Tuesday, July 27, 2021
Medway Planning and Economic Development Board
155 Village Street
Medway, MA 02053
Live and Remote

PUBLIC HEARING CONTINUATION - MEDWAY PLACE SHOPPING PLAZA SITE PLAN 98, 108, AND 114 MAIN STREET:

Re: Medway Plaza, 98, 108, 114 Main Street, Medway, Massachusetts
Application for Major Site Plan Review

SUPPLEMENTARY SITE PLAN SUBMITTAL
July 14, 2021

C1.00

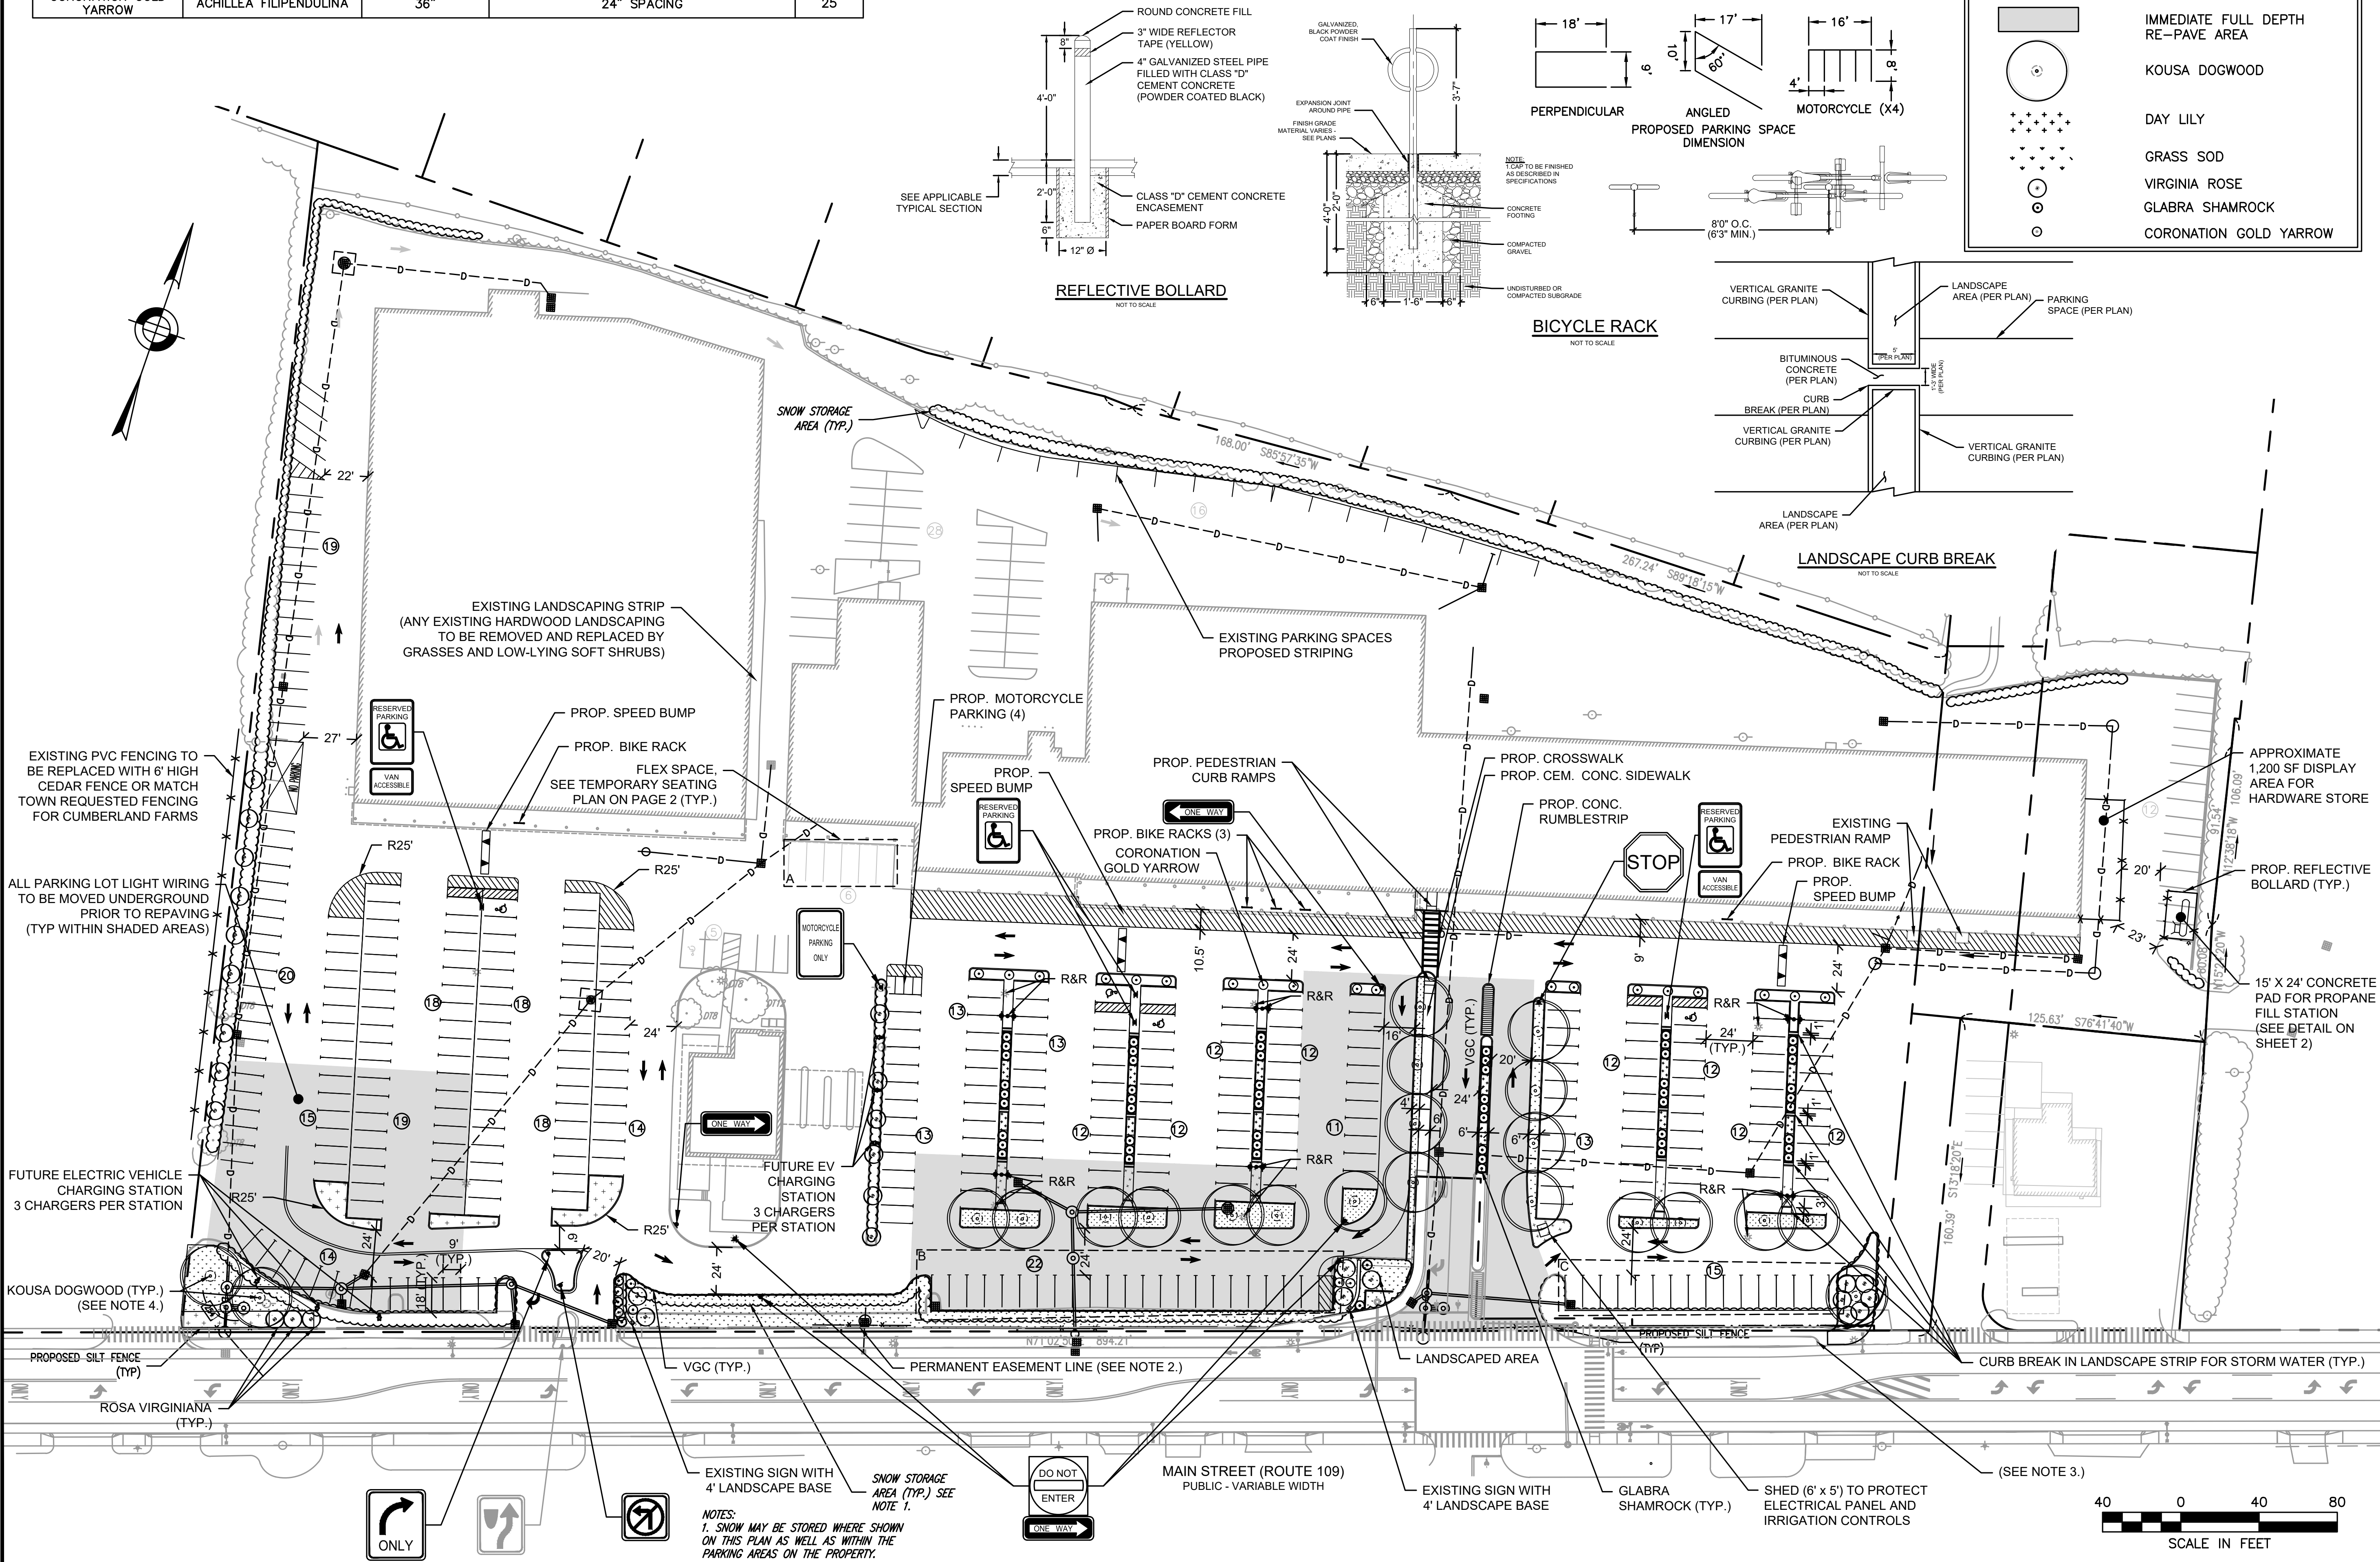
6. **Section 207-13-G(3)(a) requires parking drive aisles to be 24 feet wide. Most of the aisles are one-way for angle parking and those aisles are 18 or 19 feet wide. Section 207-13-G(2)(b) allows for angle parking if the applicant can show proper maneuverability can be achieved. However, pull through angle parking is not allowed. It is not clear if this is achieved. The aisles are now 24' wide except for one-way aisles.**

7. **Section 207-13-I requires electric charging stations. Under the formula, 9 charging stations are required for 400-500 spaces. Electric charging stations providing 9 charging ports are now included in the plan.**

8. **Section 207-19-B(2) requires perimeter landscaping around the entire site. The plan now shows perimeter landscaping along most of the Main Street frontage. The areas are labeled as “Landscaped area”, but details of the landscaping are not provided.**

9. **Section 207-19-C(1)(a) requires that a minimum of 10% of internal parking area shall be provided as landscaped island areas, exclusive of perimeter landscaping. 207-19-C(1)(b) requires landscape islands at the ends of rows with more than 15 parking spaces. ... Section 207-19-C (1)(d) requires at least 1 deciduous shade tree per 6 parking spaces. ... The plan says there are 433 spaces so 72 trees would be required. There are 22. The parking rows now have landscaped islands except for the three rows in front of Ocean State Job Lot. The applicant says that contractual obligations preclude the islands at these locations.**

RESPONSE: This appears to be resolved. Notably, in addition to increasing the aisle width, Medway Realty will realign the parking spaces so that they will be perpendicular to the aisles, and will install granite

RESPONSE: Medway Realty has proposed a total of nine charging stations. In response to comments, the charging stations will be split up into two locations, as shown on the Revised Site Plan. Medway Realty would agree to a condition that the charging stations be installed and operable within five years. Prior to resurfacing the relevant portion of the parking lot, Medway Realty will put in place the conduits necessary to connect these charging stations to the grid when installed.

RESPONSE: The Revised Site Plan includes substantial landscaping in light of the existing conditions and shows what plants and flowers will be planted in these areas.

RESPONSE: Medway Realty believes that the proposed landscaping, consisting of 22 kousa dogwoods, raised landscape islands at the end of aisles except for those few aisle ends by Ocean State Job Lot, raised landscape areas between parking rows, and other features is appropriate given the reason for and the scope of changes in the parking lot. Medway Realty has not proposed raised landscape islands at the end of the parking rows near Ocean State Job Lot due to concerns with emergency vehicle access, not contractual obligations. However, the absence of trees in the portion of the parking lot that primarily serves Ocean State Job Lot is due to concerns with contractual obligations.
